Council Bill No. B 285-13

Re: CVS Pharmacy C-P Plan - rezoning & development plan request (Case 13-127)

**AGENDA REPORT
PLANNING AND ZONING COMMISSION
September 19, 2013**

**Case 13-127: CVS Pharmacy
C-P zoning and development plan**

Exhibit 1: Conceptual Development Plan (Provided by Others)

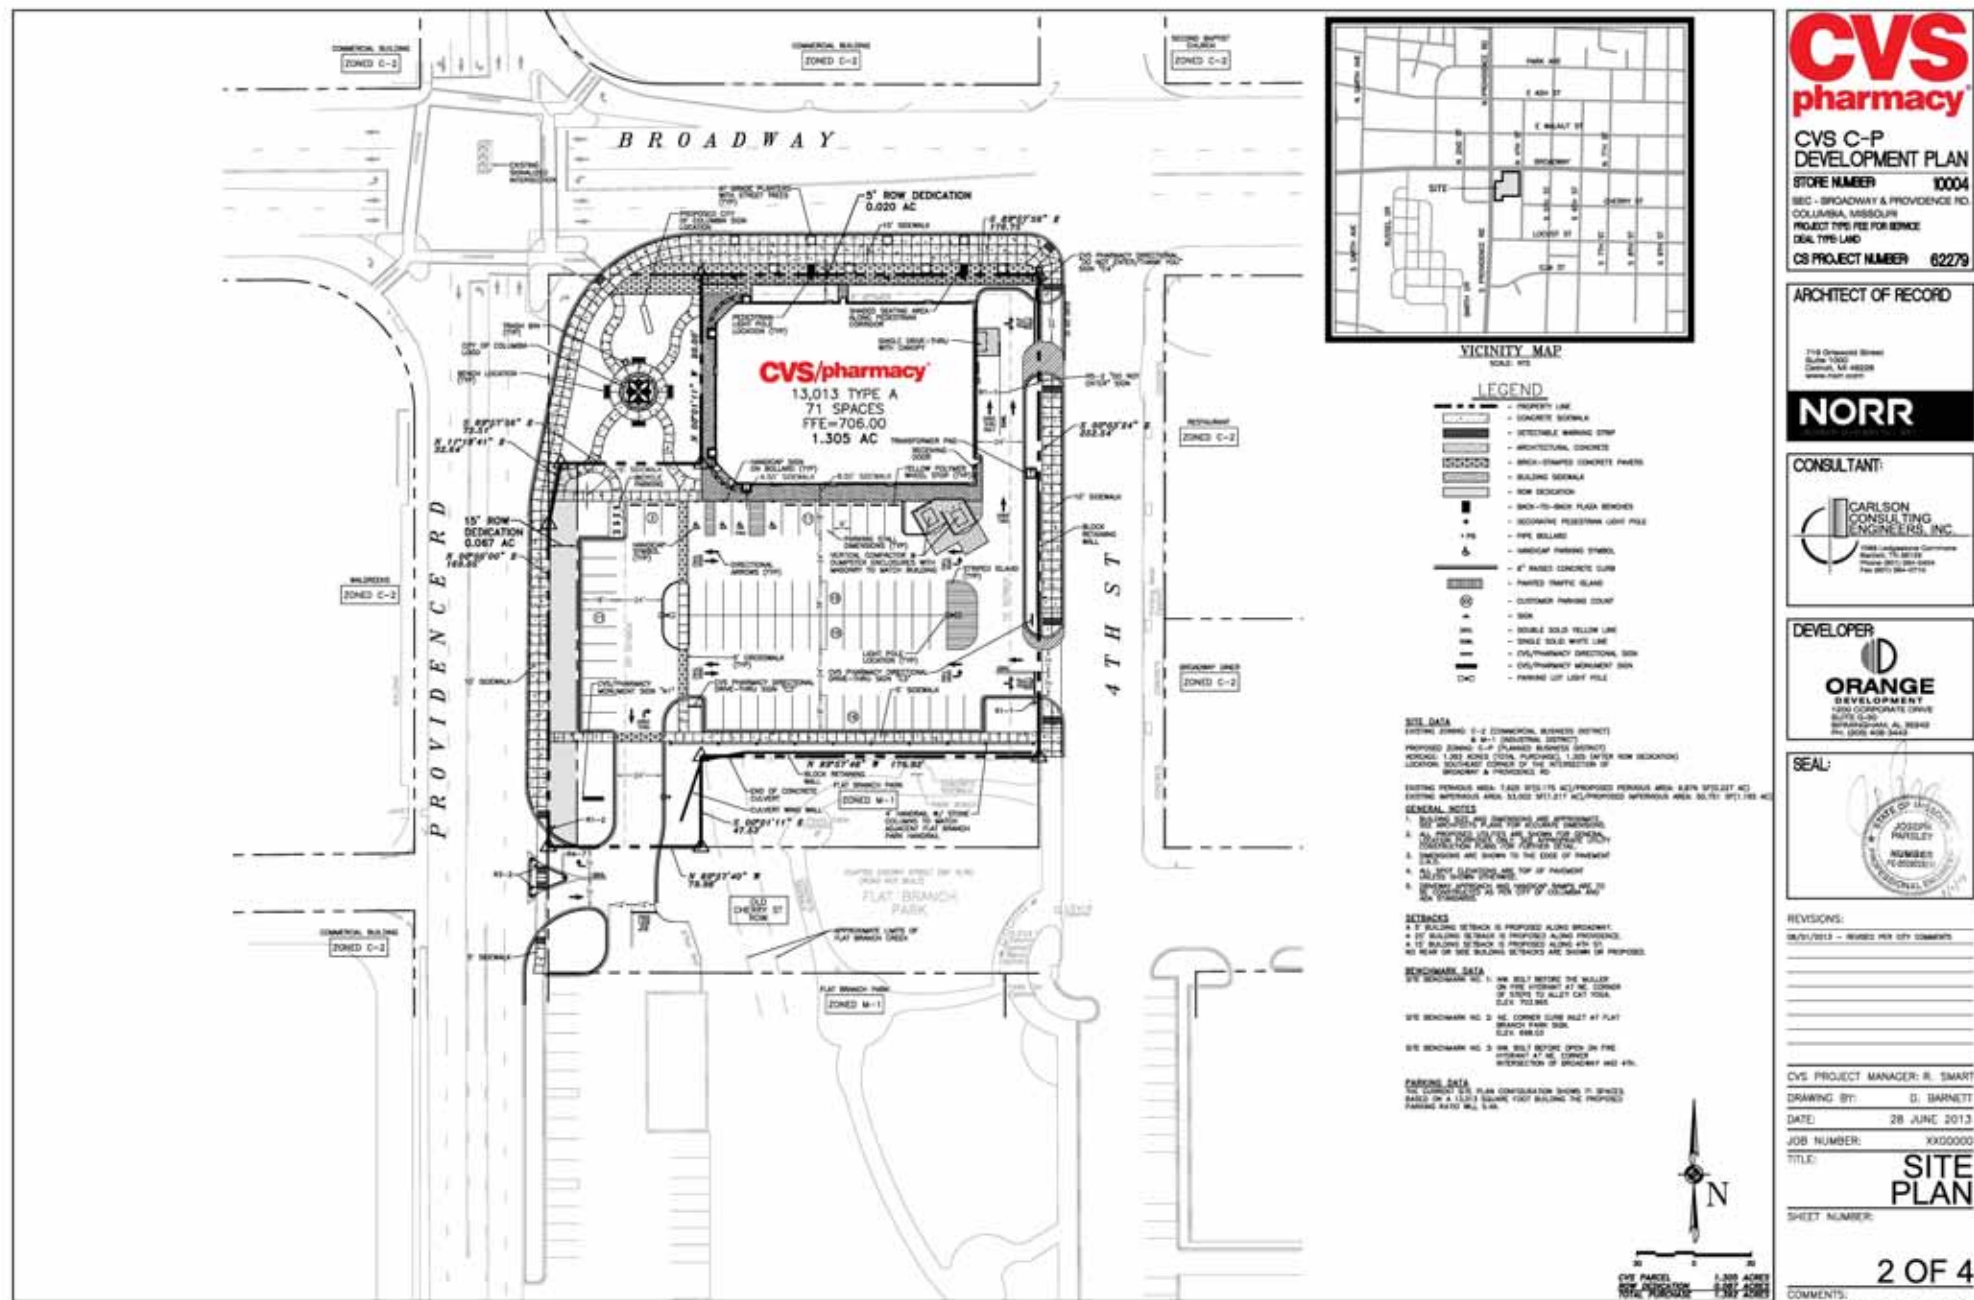
Based on the concept plan provided, right-in/right-out access to the site is proposed on Providence Road via a new stop controlled driveway opposite Cherry Street and a full access driveway on 4th Street via a new stop controlled driveway. As requested by City of Columbia Staff, the pharmacy drive-thru exit has been relocated from existing onto Broadway to exiting onto 4th Street, south of East Broadway. **Exhibit 1** depicts the conceptual development plan.

In our opinion the proposed access for the development would significantly improve conditions near the intersection by providing improved access management along East Broadway and 4th Street by eliminating up to 21 head in parking spaces (7 on East Broadway and 14 on 4th Street) and by converting the City parking lot in the southeast corner of East Broadway and Providence Road to a pocket park and providing improved pedestrian facilities along East Broadway.
